Report to Planning Committee 11 July 2024

Report Summary			
Application Number	23/01755/RMAM		
Proposal	Submission of Reserved Matters (layout, scale, appearance, landscaping) for Phase 2 of 19/00854/OUTM for 309 dwellings including details to discharge Conditions 5, 12, 13, 16, 17, 22 and 24.		
Location	Flowserve Pump Division, Hawton Lane, Balderton, Nottinghamshire, NG24 3BU		
Applicant	Lovell Partnerships and CB Collier NK Limited	Applicant	Lovell Partnerships and CB Collier NK Limited
Web Link	<a href="https://newark-sherwooddc.gov.uk/23/01755/RMAM">23/01755/RMAM   Submission of Reserved Matters (layout, scale, appearance, landscaping) for Phase 2 of 19/00854/OUTM for 309 dwellings including details to discharge Conditions 5, 12, 14 (in part), 16, 17 (in part) and 22.   Flowserve Pump Division Hawton Lane Balderton Newark On Trent NG24 3BU (newark-sherwooddc.gov.uk)</a>		
Registered	10.10.2023	Target Date Extension To	09.01.2023 19.07.2024

*Fig. 5 Proposed Site Layout Plan extract showing part of the S106 Parking Area (adjacent to the eastern factory boundary)*

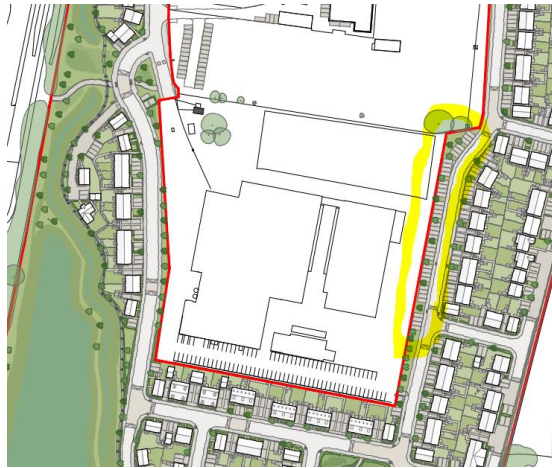
- 7.35. A large expanse of parking is proposed on the western side of the site, adjacent to the

eastern boundary of the SSC (i.e., opposite plots 59-73, see Fig. 5 below). Following negotiations, this has been broken up into blocks of 4 spaces with intervening landscaping but nevertheless results in parking spaces opposite each other in the street scene which is generally discouraged in the Council's Parking SPD. However, this area of parking would serve the SSC site and was specifically secured by the S106 agreement (which was based on an indicative plan showing parking in this location). The parking would serve a necessary purpose for the SSC and has been designed to incorporate landscaping to mitigate the expanse of hard surfacing which is acceptable in this case in light of the S106 requirement.

Fig. 8 Trees T30-T36 outside of the Application Site

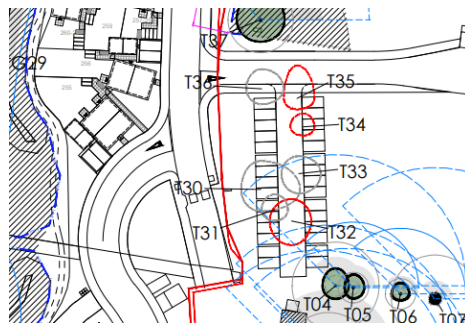
- 7.61. Save for those listed above, no other trees **within** the site are proposed for removal. It is noted that outside of the red line of the application, adjacent to the SSC access there is a group of trees (T30-T36, see Fig. 8 below) that is shown as being removed to provide parking spaces for the adjacent SSC. Given these trees are outside of the application site boundary their removal is not for consideration as part of this application, however it is noted that the proposed S106 Parking Plan submitted indicates that this land would be used to provide the parking spaces required for the SSC as part of the S106 agreement attached to the outline consent. These trees are a mixture of category U (3) and C (3) trees with <10-year life spans that would not warrant protection by TPO. Therefore, there would be no objection to their removal.

Fig. 11 PRow Plan Extract showing Routes described above

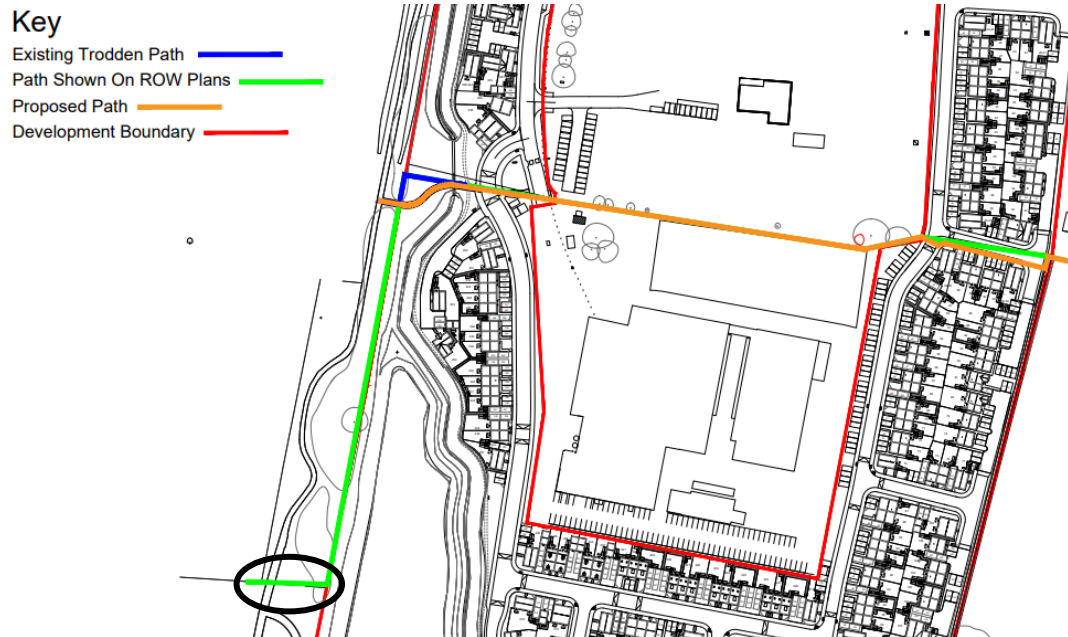
- 7.100. Turning now to FP11 – the original legal line of the public right of way is shown on the plan extract below in green spanning east-west between the Factory and the SSC site from Mead Way and then down the western boundary and connecting to the Sustrans National Cycle Network no. 64 as circled in black in fig. 11 below. Whilst this is the legal line of the PRow, for many years (since at least 2007, it would appear from reviewing aerial imagery) the public have utilised a more direct route to connect into

the Sustrans as shown by the blue line on the plan below. This informal 'trodden path' includes a makeshift palette bridge across the drainage ditch (which is in a poor state of repair).

- 7.101. The RoW Officer has confirmed, as set out in the site description section of this report, that the 'legal' link into the Sustrans as shown circled above was extinguished as part of the development of Land South of Newark<sup>2</sup>. There is therefore no existing legal public right to pass from the development site into the Sustrans network.
